**R15YB**

**IMPORTANT SAFETY RECALL NOTICE**

**NHTSA RECALL NO. 15V059 SCHOOL BUS  
NHTSA RECALL NO. 15V060 NON-SCHOOL BUS**

## Potential for Rear Engine Exhaust Hangers Failing

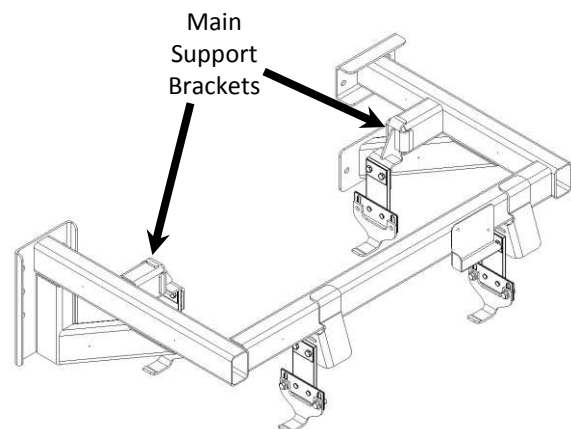
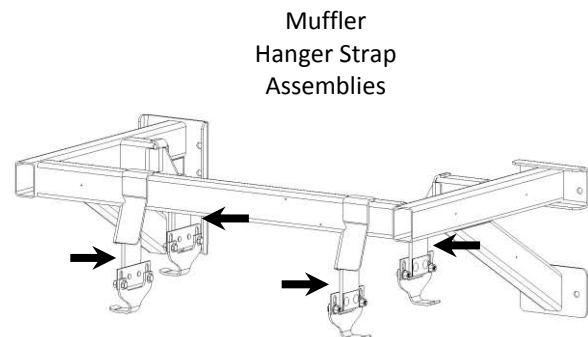
The rubber SCR and DPF hanger strap assembly may fail under extreme conditions causing extensive damage to the SCR and DPF modules.

1. Park the bus on a level surface, apply parking brake, turn off engine, remove ignition key, and chock wheels.
2. Locate the four muffler hanger strap assemblies supporting the SCR and DPF at the rear of the bus.

Note: Inspect welded Main Support Brackets for damage (bent brackets or cracked welds) before installing new muffler hanger bracket assemblies. Replace, as needed.

Install new exhaust hanger strap assembly 10040843 (4 Places); and exhaust support cables, 10040841.

3. Support the SCR and DPF, and replace muffler hanger strap assemblies (4 Places) with new assemblies 10040843 and add two exhaust support cables 10040841, two bolts 00803171, two nuts 00543934, and two nuts 02171809 per exhaust hanger strap assembly. Drill out slots at eight (8) mounting locations to 13/32 inch diameter. Do not reuse old nuts.

Torque upper 3/8" nut that comes with new bracket assembly 10040843 to 72 – 78 in-lb.
